HISTORIC PRESERVATION BOARD STAFF REPORT

202 N. Swinton Avenue

Meeting	File No.	Application Type
October 16, 2024	2024-192	Certificate of Appropriateness, Level 1 Site Plan Modification, Demolition, and Variance

A10 FINAL REAR (WEST) ELEVATION: MAIN STRUCTURE

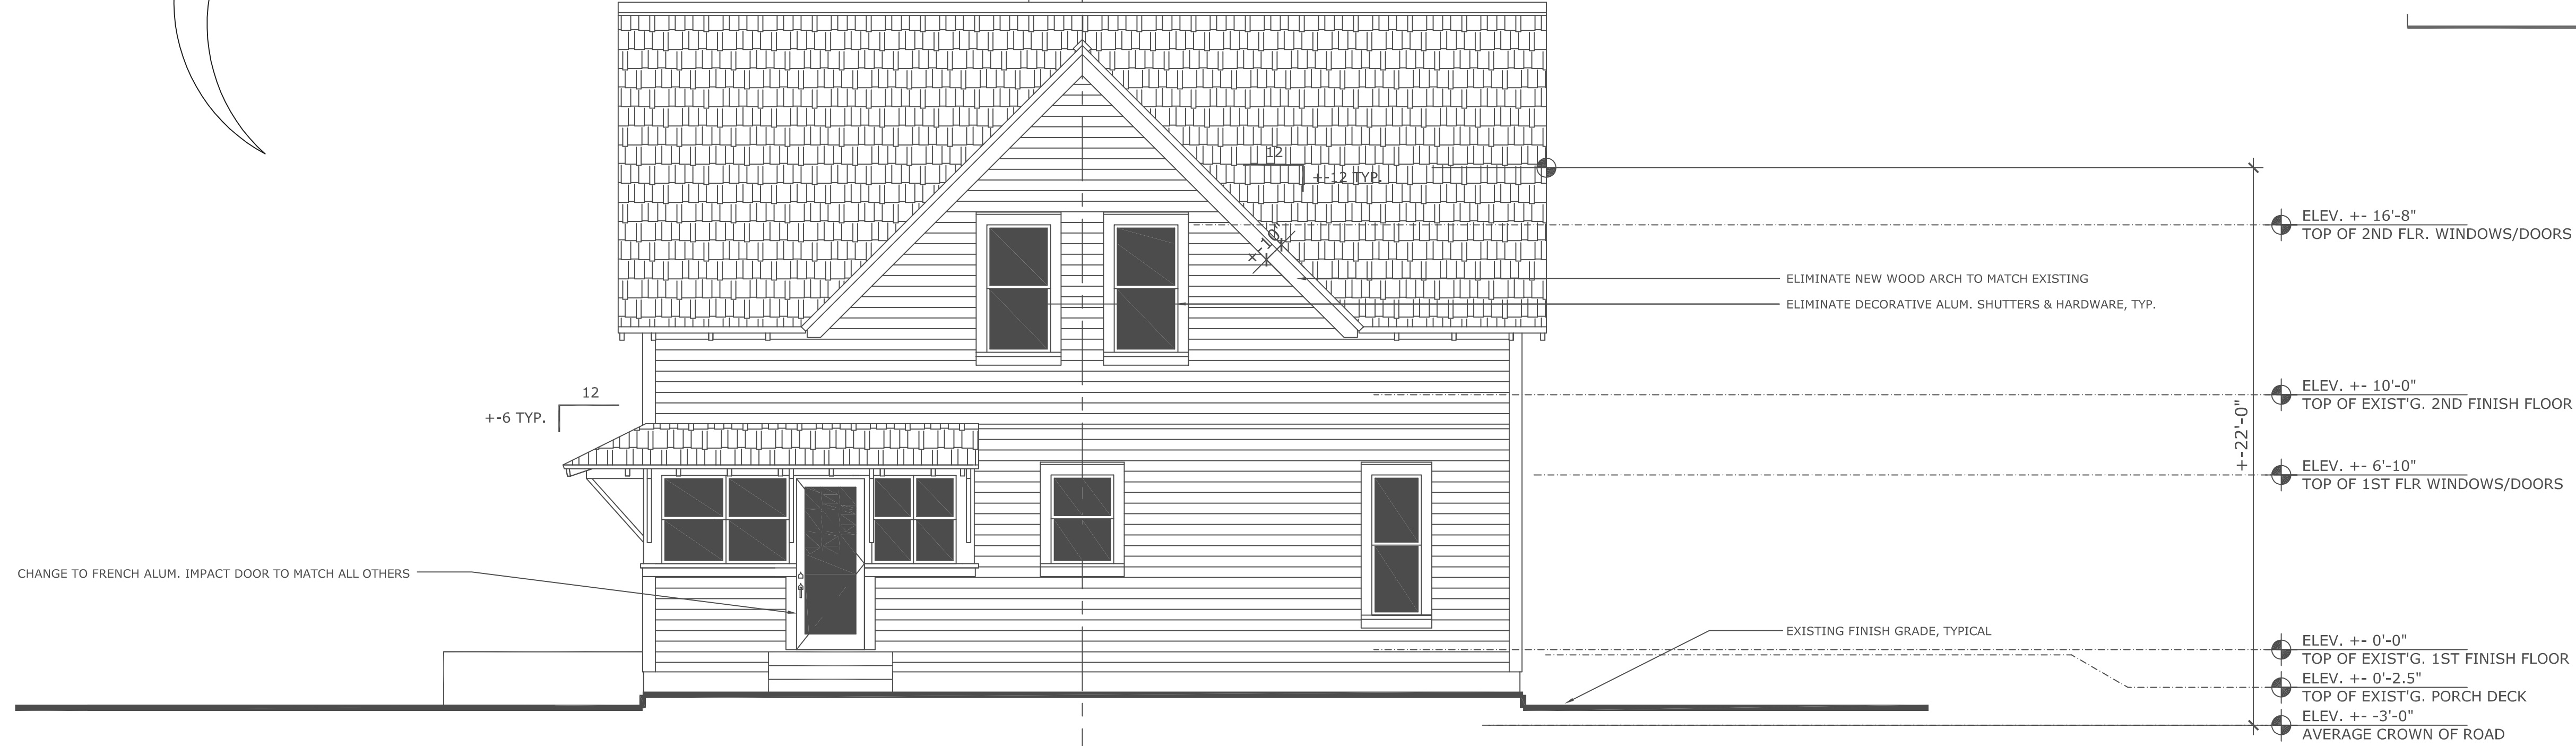
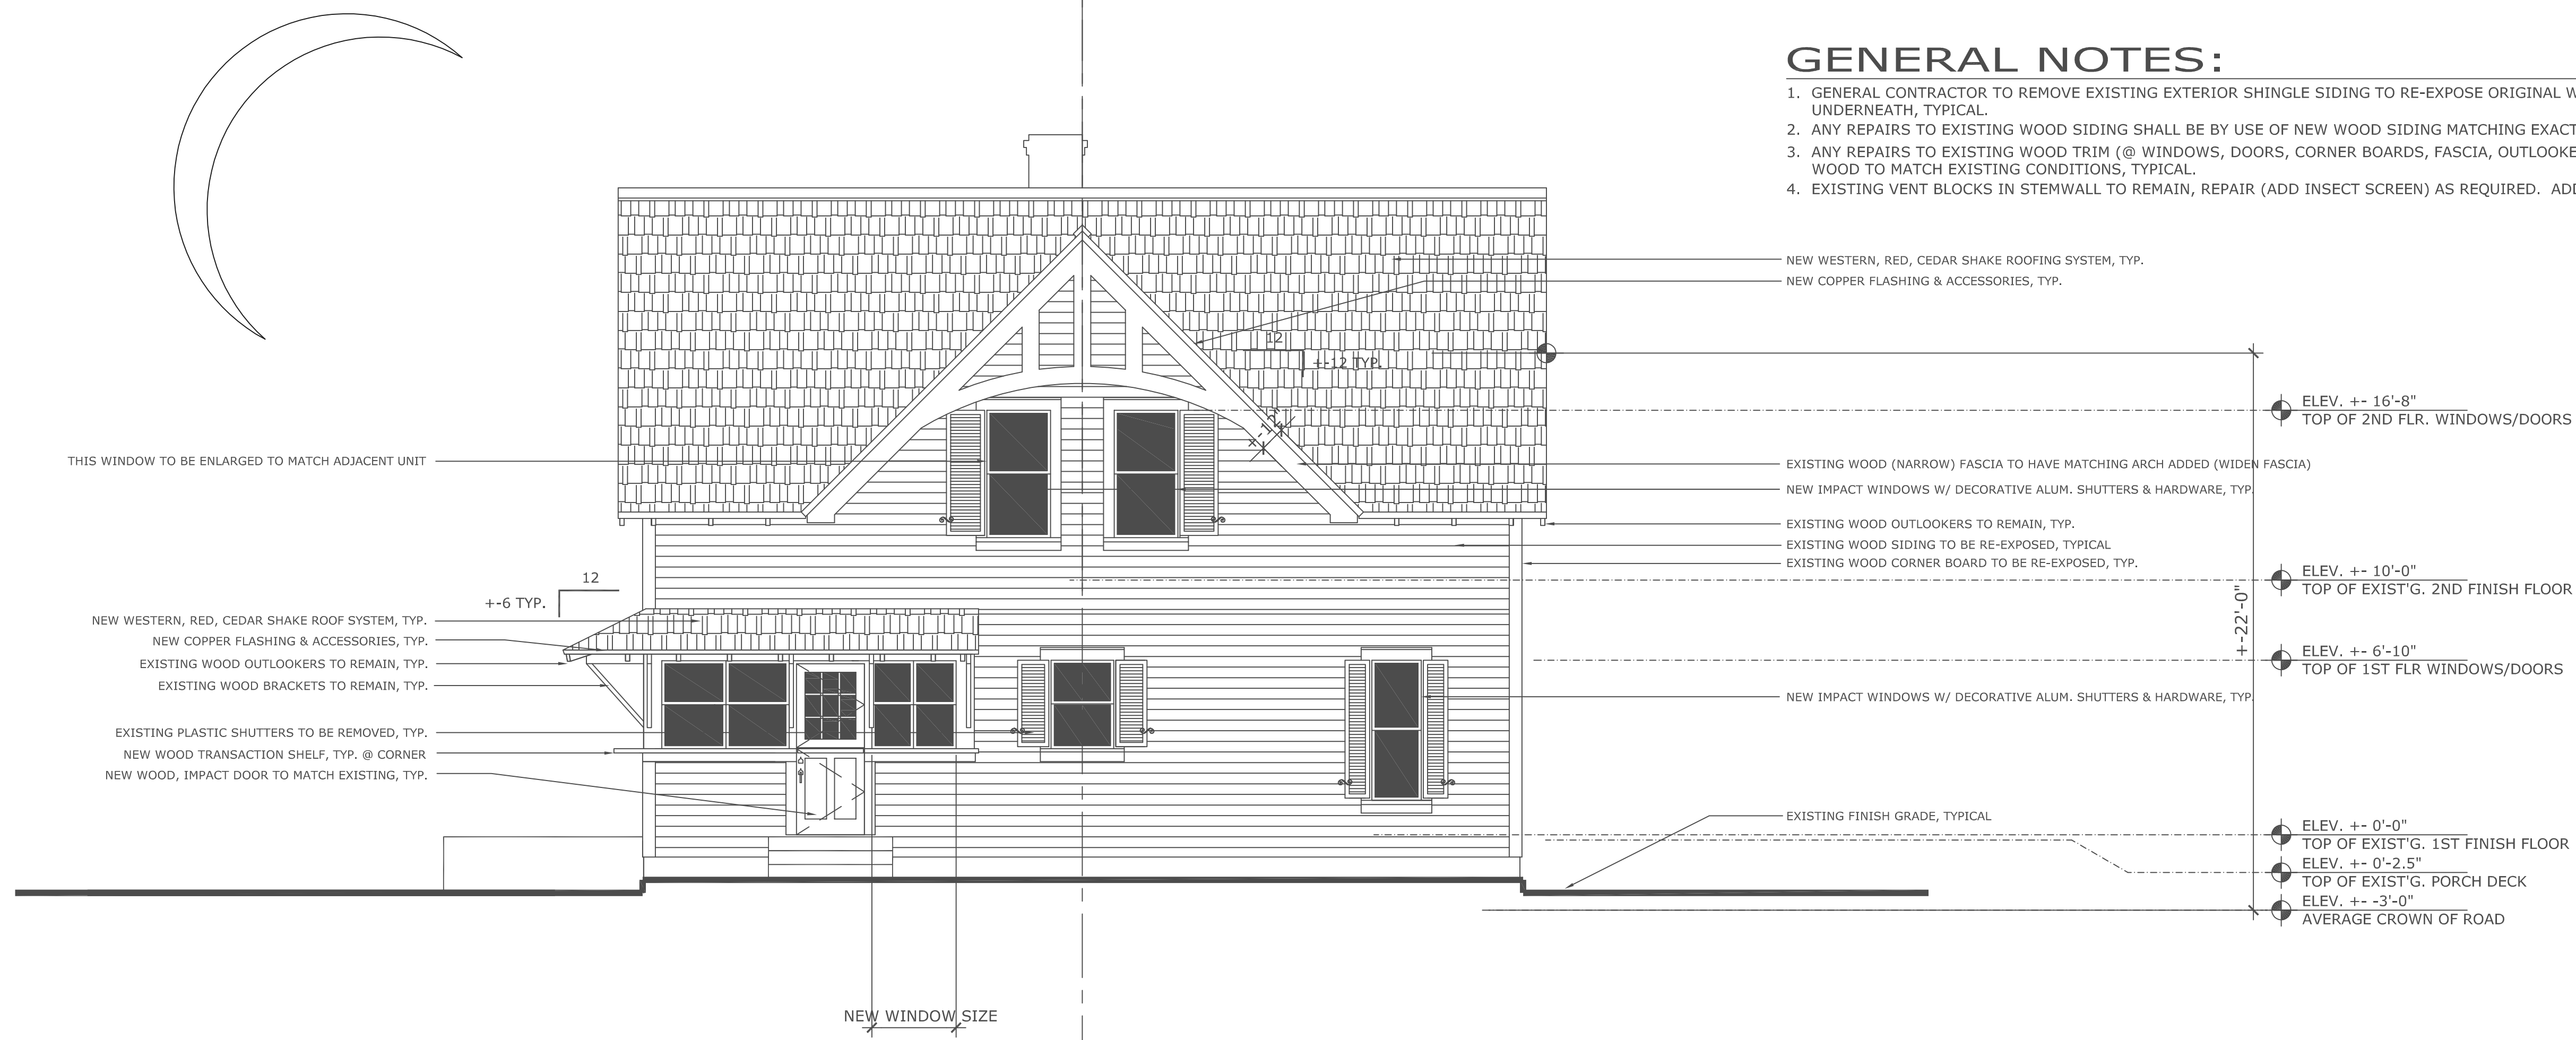
1. North Elevation: Removal of the approved roof eyebrow over the side door.
2. West Elevation: Changing the rear entry door to match all other doors, which are solid pane class doors.

3. North Elevation: Removal of the approved roof eyebrow over the side door.
4. West Elevation: Changing the rear entry door to match all other doors, which are solid pane class doors.
